Comment A – Some hydrologic considerations for storage of High-Level nuclear waste at the Holtec Site in Lea County, New Mexico

COMMENT (286)

PUBLICATION DATE: 3/30/2018

CITATION # 83 FR 13802

**DOCKUM WATER LEVELS WITH FLOW LINES (FROM FUNG, 2008)**

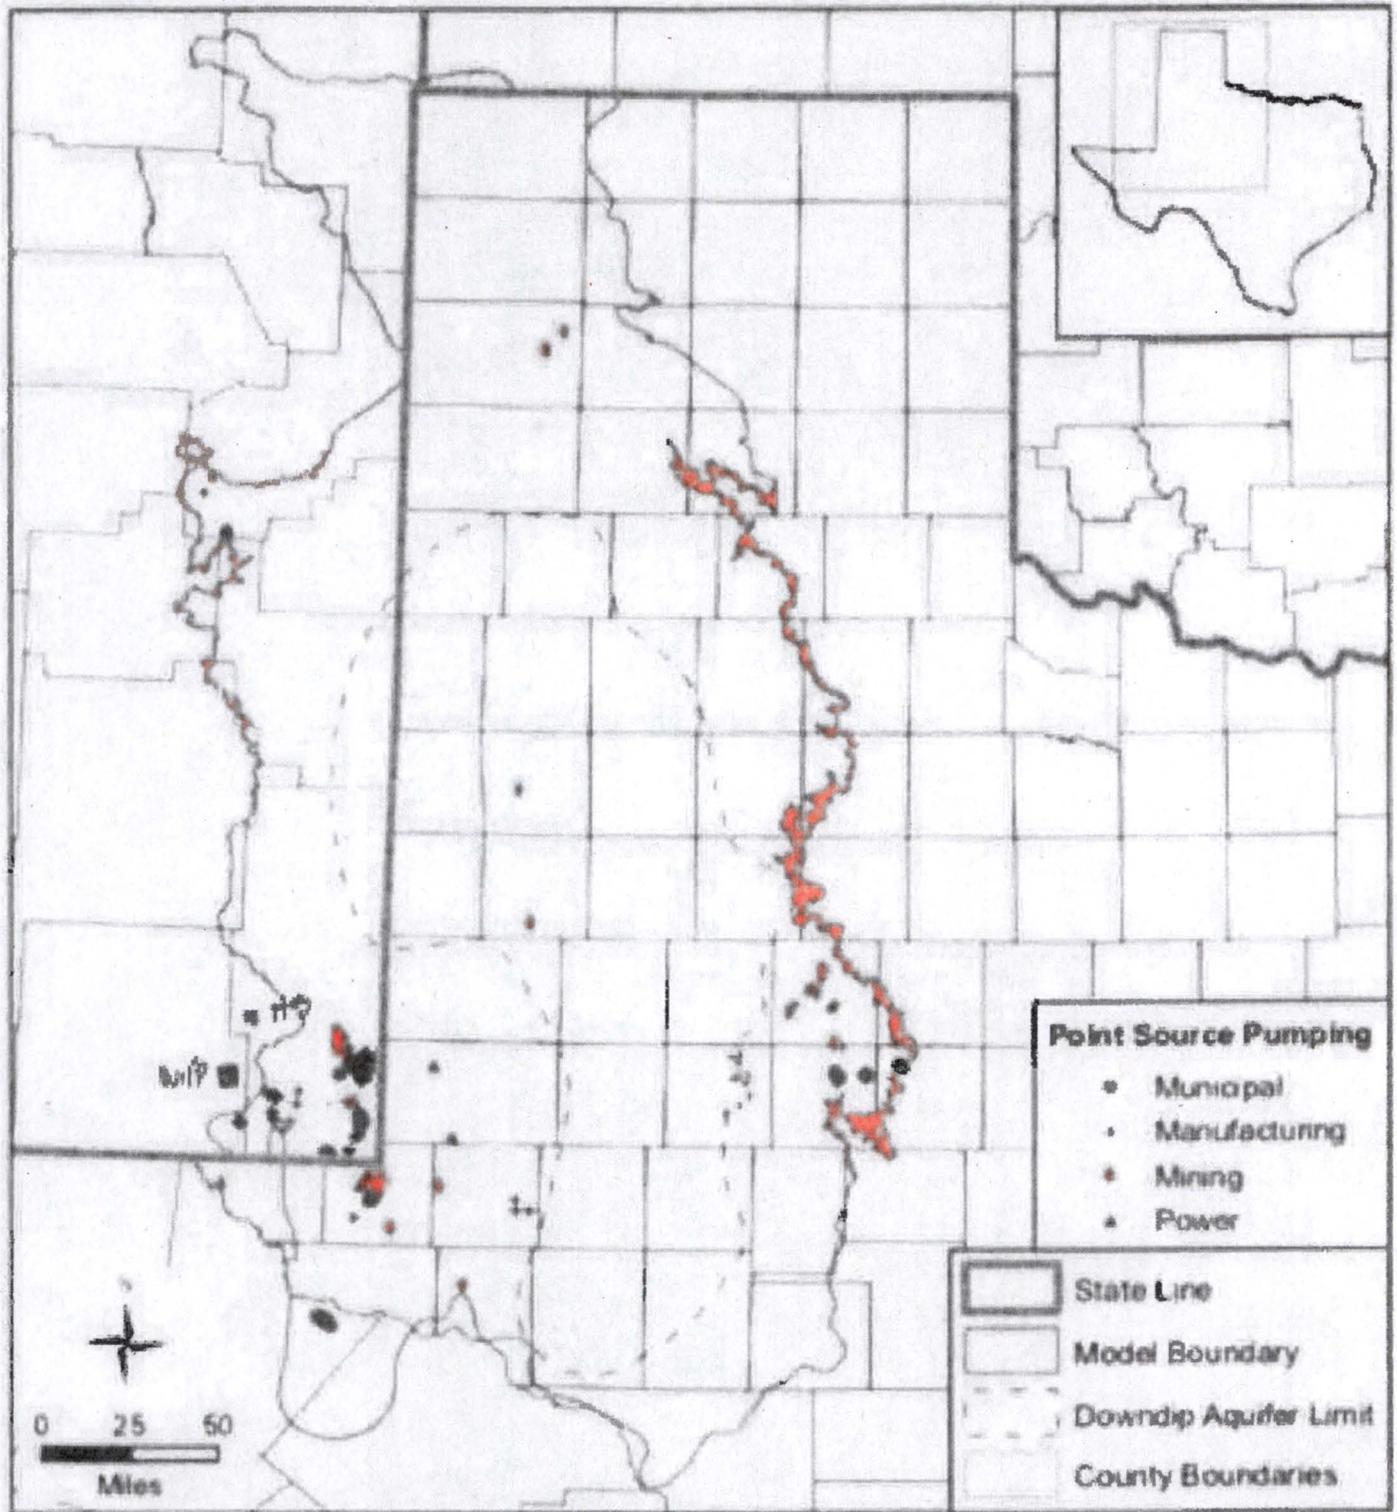
traveling contaminant fronts from HS could be entrained in ground-water flow within this aquifer and transported to the south and southeast towards commercial pumping centers (accessible environment) in southern Lea County, NM and Winkler County, TX (Ewing, 2008 – water-level map (Figure 5), flow lines, and pumpage map - Figure 6)), or possibly flow directly into the Pecos River in Ward County, Texas (Figure 5) and from there into the Rio Grande. Until subsurface work is done to check on the presence or absence of the Dockum aquifer below HS (or below a new location if the HS is moved), this problem is only a potential hazard. If geologic work is done to investigate this issue, it should be reviewed by independent agencies such as the USGS, the N M Bureau of Geology, and the NM .

FIGURE 7 - GENERAL LOCATION MAP AND CORBET MODEL BOUNDARIES  
DRAWN ON BAHMAN (1967) MAP OF RUSTLER FM.

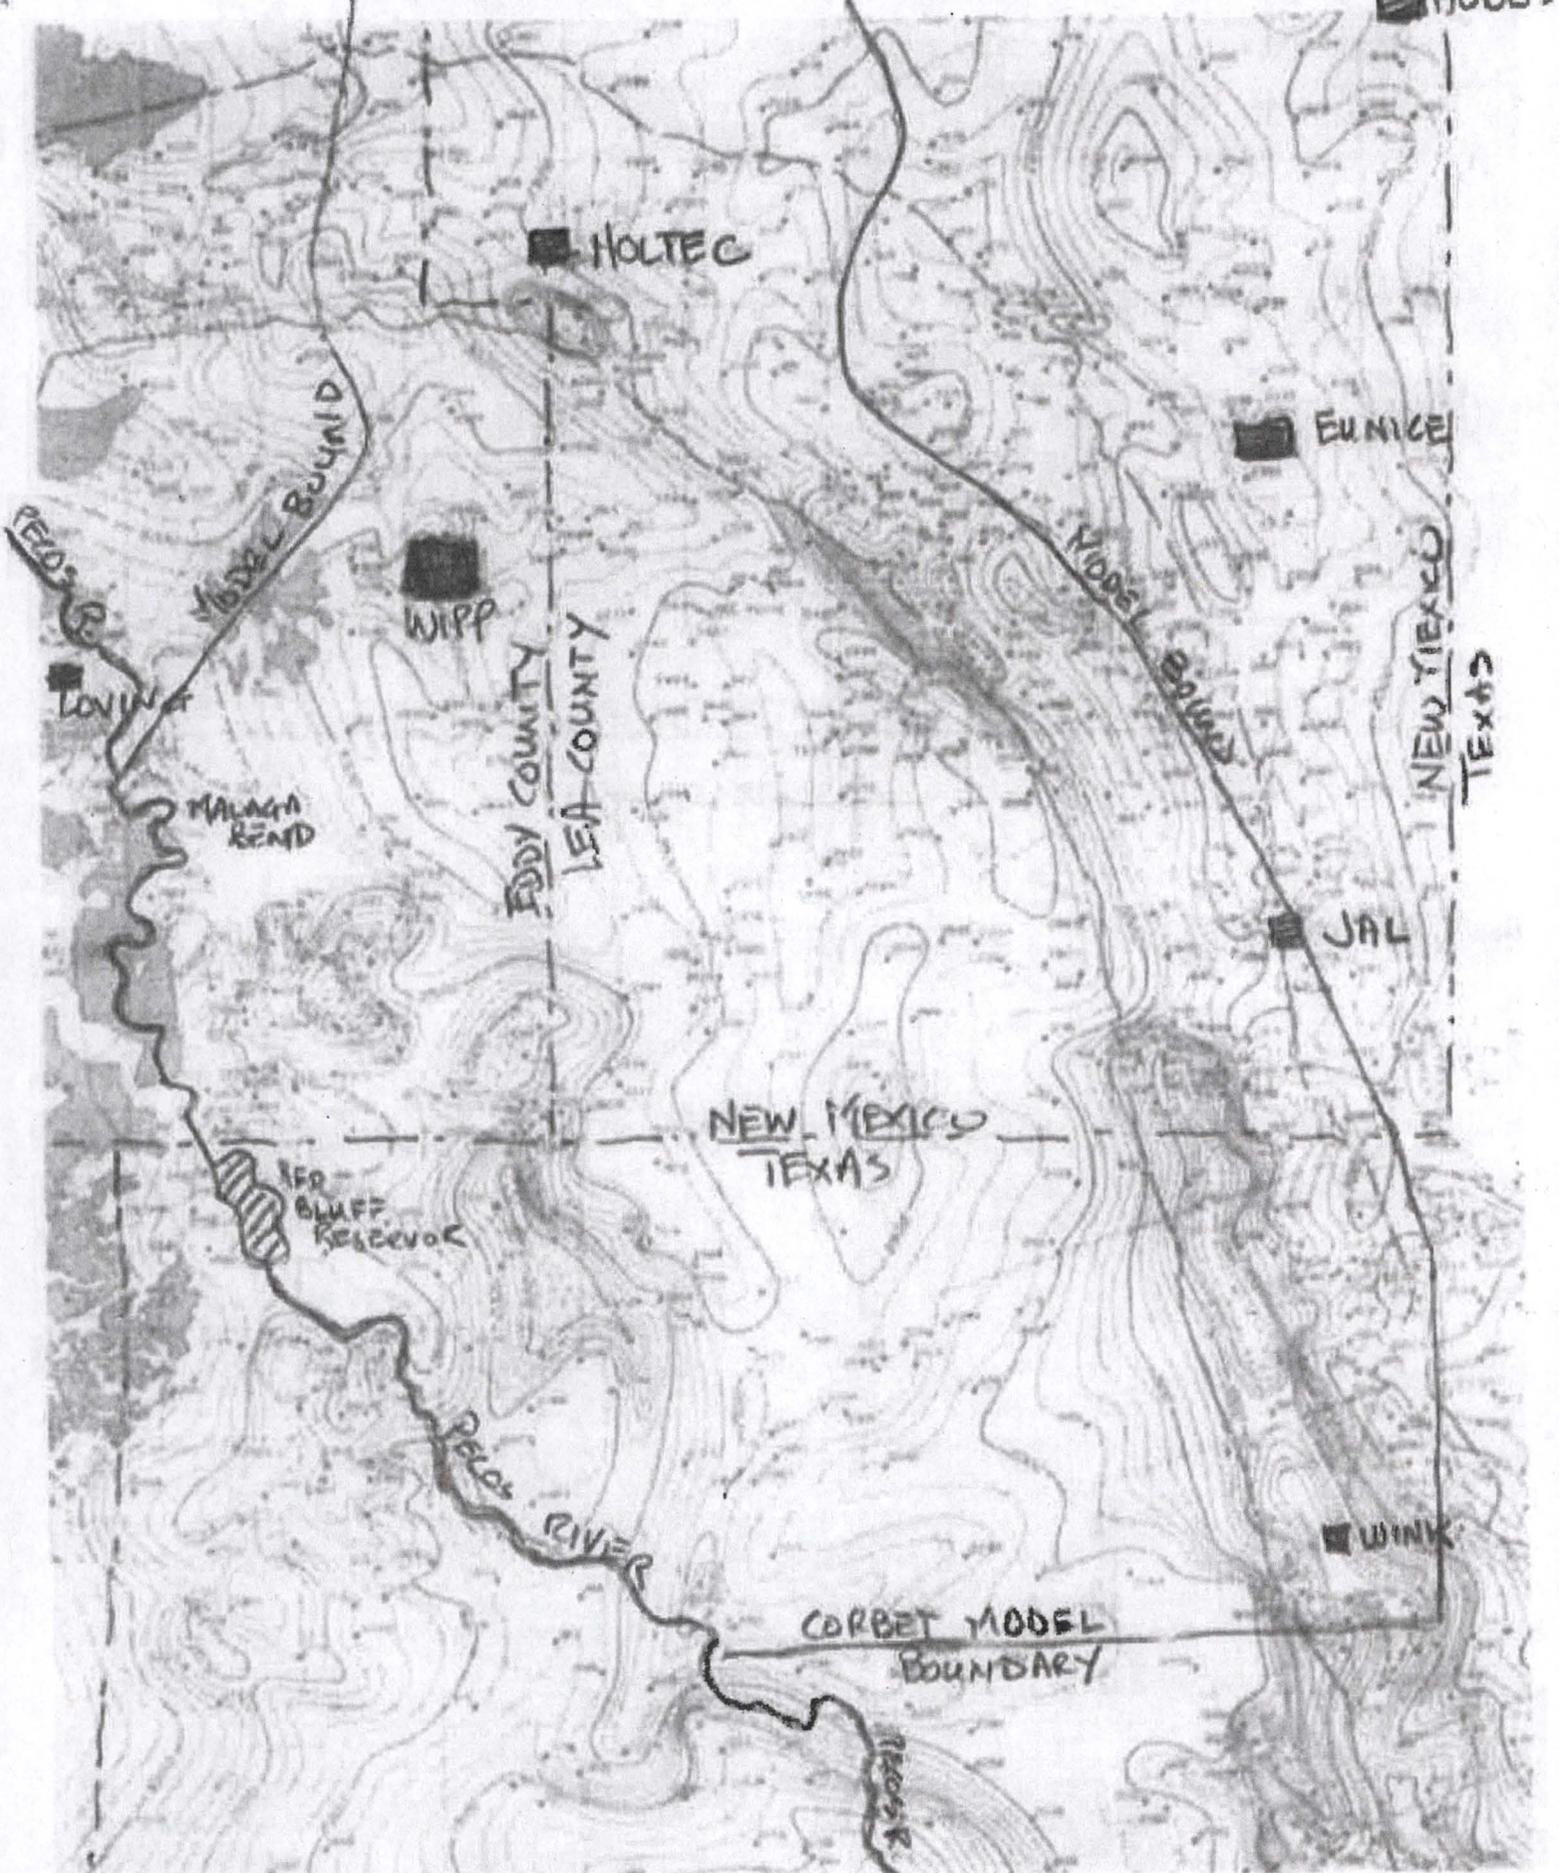
- C) - **Rustler Aquifer** - the Permian Rustler Formation and its aquifers lie beneath the HS (Bachman, 1987, Map of Rustler Fm – Figure 7). Deeper vertical contaminant transport through and below the Triassic within the bounds of HS could reach the Rustler Formation and there, contaminants could be transported southward in ground-water flow within this confined aquifer, and eventually taken into the Pecos River itself (Corbet, 1996, water-level map with flow lines – Figure 8) – and once again, eventually into the Rio Grande.. Hale (1945) suggested that saline waters within the Rustler Aquifer did flow into the Pecos River within New Mexico in the reach between Malaga Bend and the Texas State line (Figure 7). Within their modeled area (Figure 7), Corbet and Knupp (1996) describe the Rustler close to the Pecos River as grading into a permeable collapse breccia through which Rustler aquifer water within the modeled area flows into the Pecos River.
